# MONTGOMERY COUNTY HISTORIC PRESERVATION COMMISSION STAFF REPORT

**Address:** 8 West Lenox Street, Chevy Chase **Meeting Date:** 6/24/2020

**Case Number:** 35/13-20W RETROACTIVE

**PROPOSAL:** Fence installation

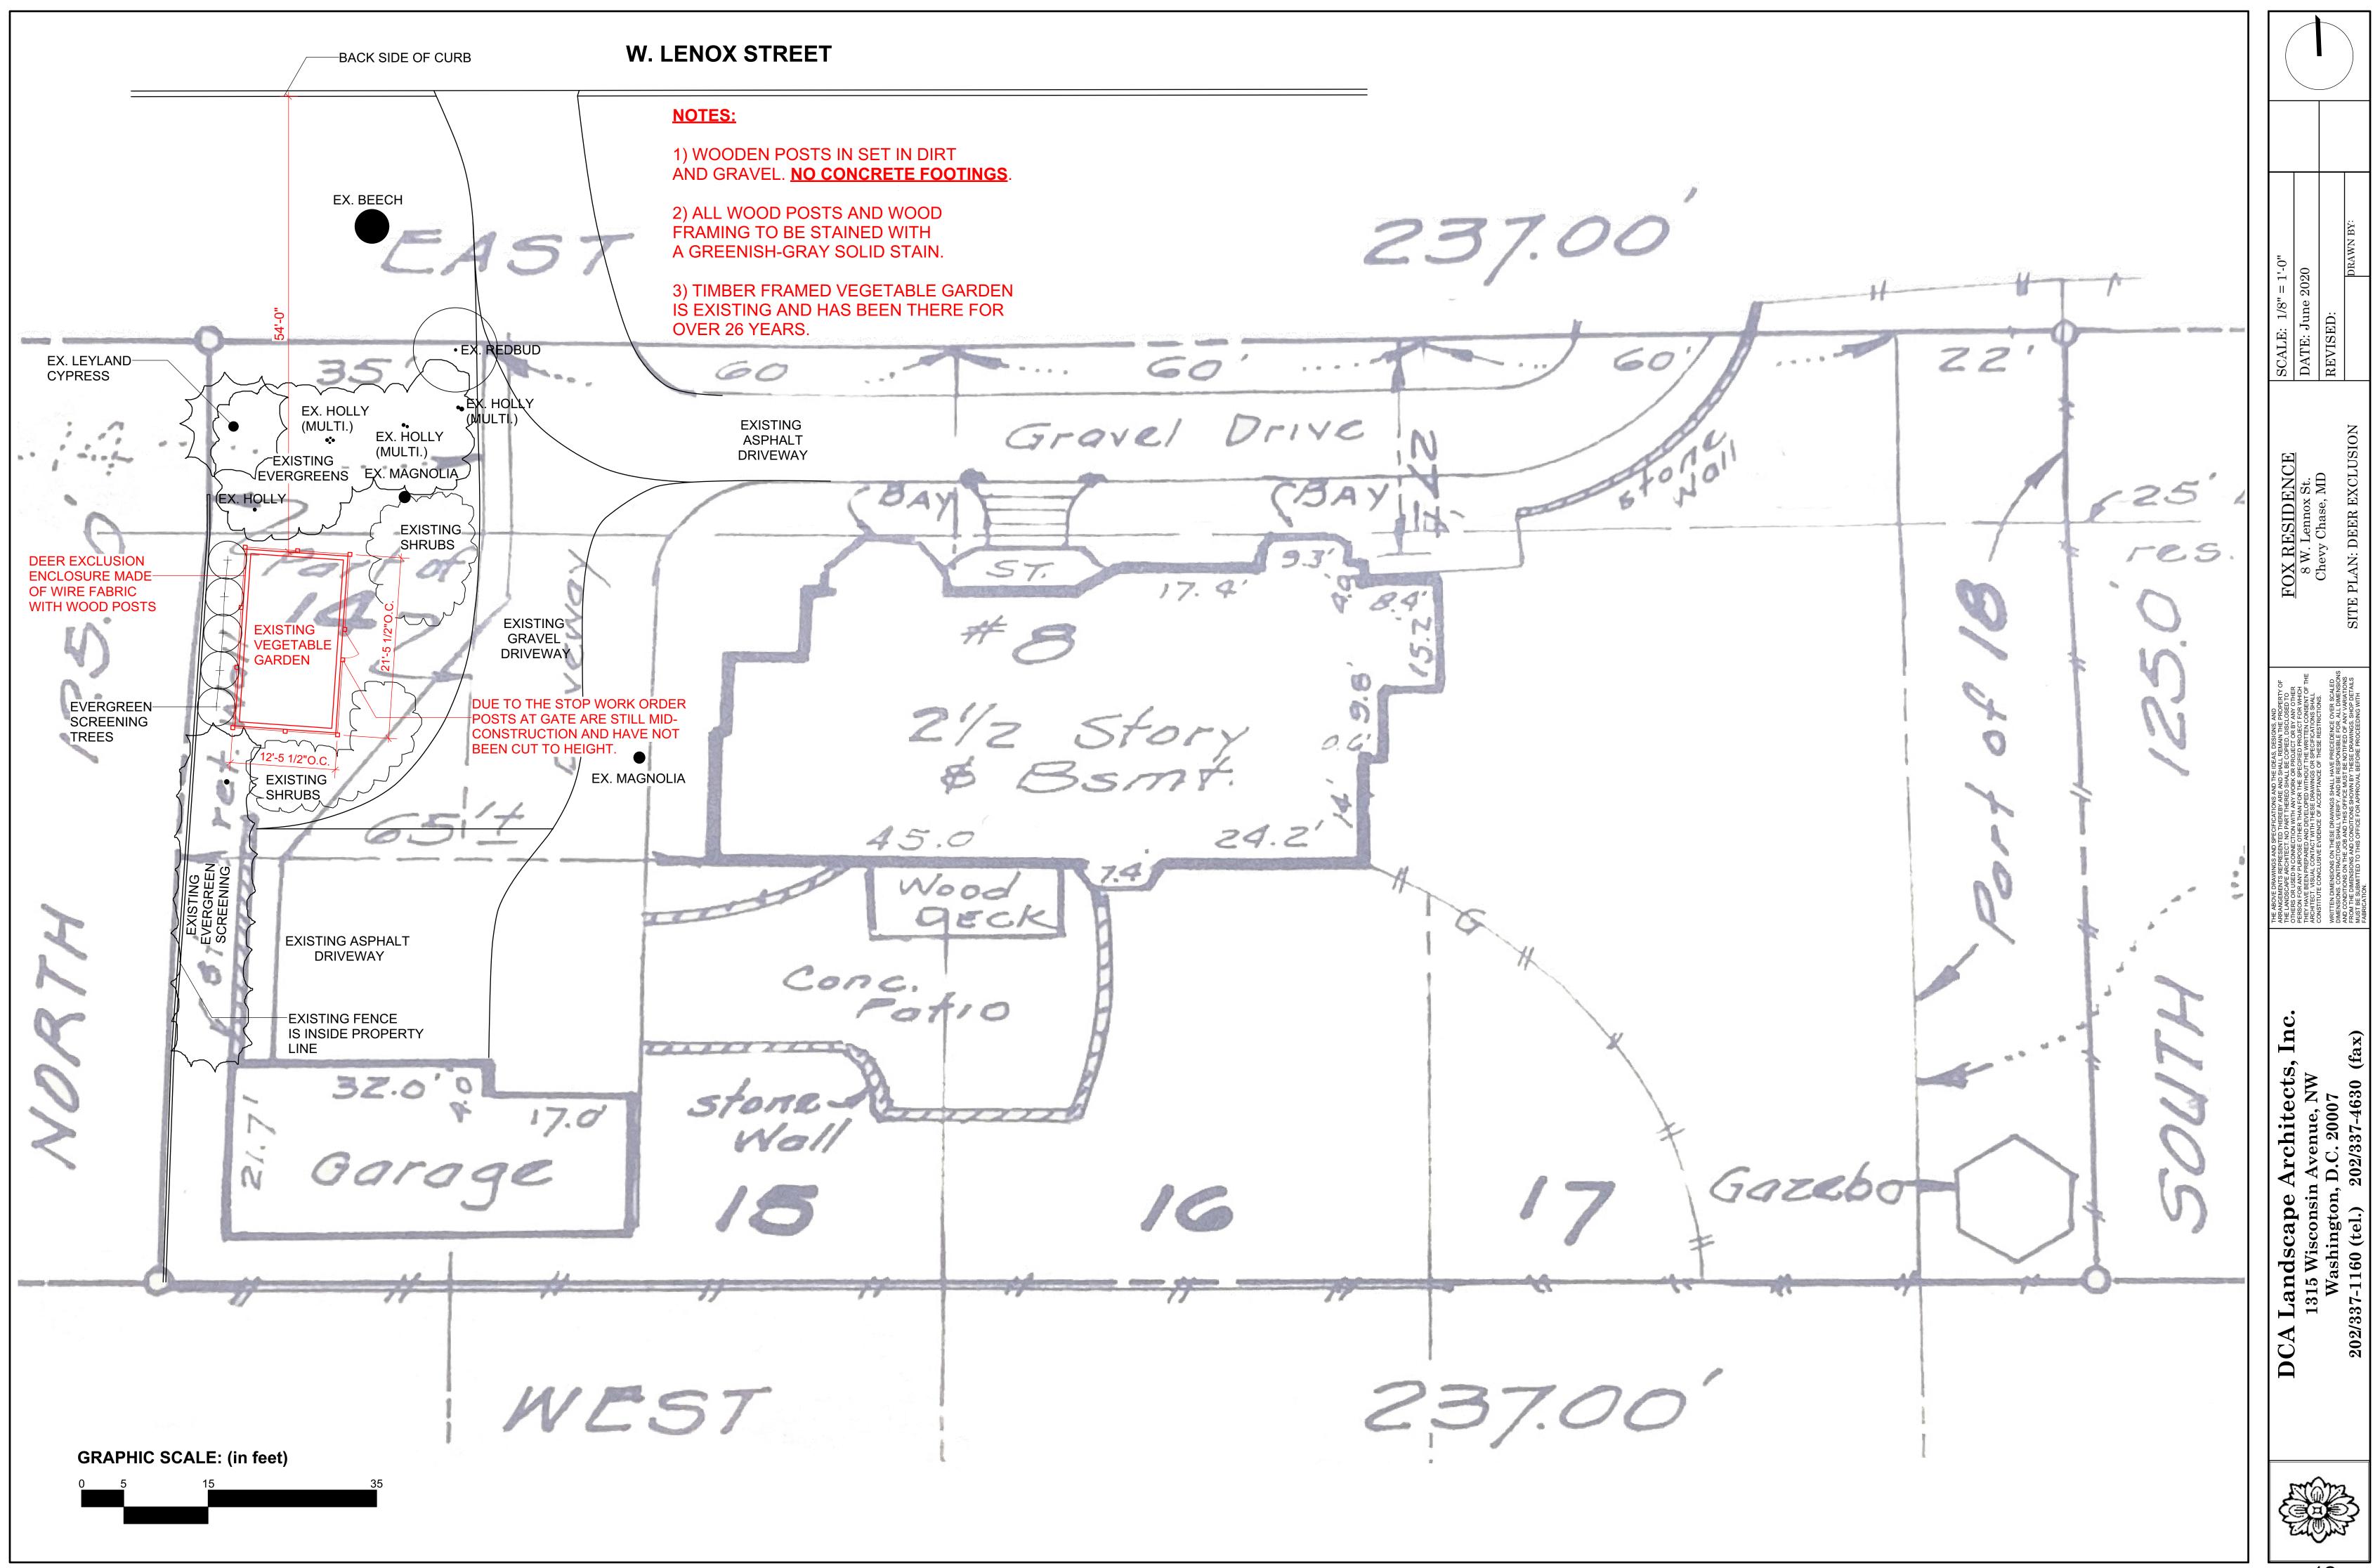
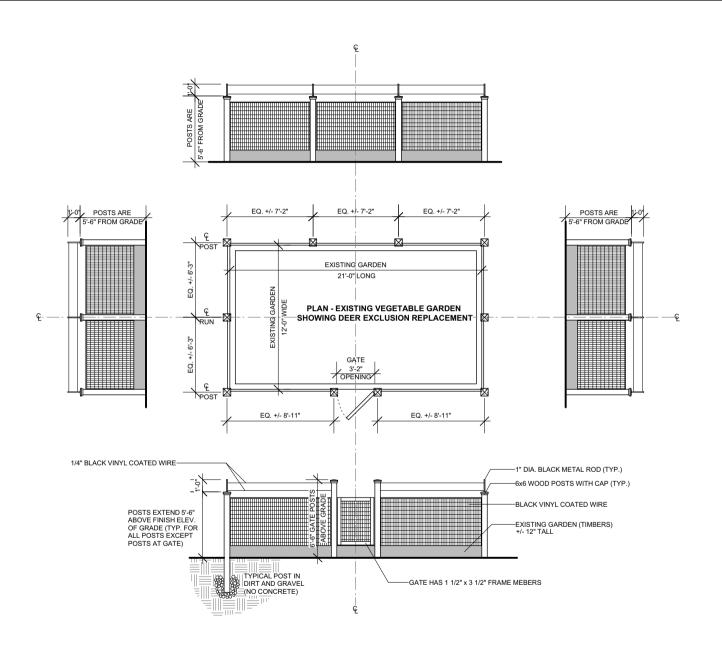
1. The height of the proposed wooden gate posts (east/left side of the proposed fence) will be reduced to 5'-6" to be consistent with the proposed wooden fence posts.

In this case, staff finds that, although the proposed fence exceeds 4' in height forward of the rear plane of the historic house, it will not detract from the openness of the surrounding streetscape, the visibility of the property from the public right-of-way, or the open, parklike character of the Village. Additionally, staff finds that the proposed materials are generally compatible with the subject property and surrounding streetscape. In accordance with the *Guidelines* for moderate scrutiny, staff finds that the proposed fence is designed so that the subject property will still contribute to the district.

However, to enhance the compatibility of the proposed fence's design, staff recommends the following condition of approval:

The height of the proposed wooden gate posts (east/left side of the proposed fence) will be reduced to 5'-6" to be consistent with the proposed wooden fence posts.
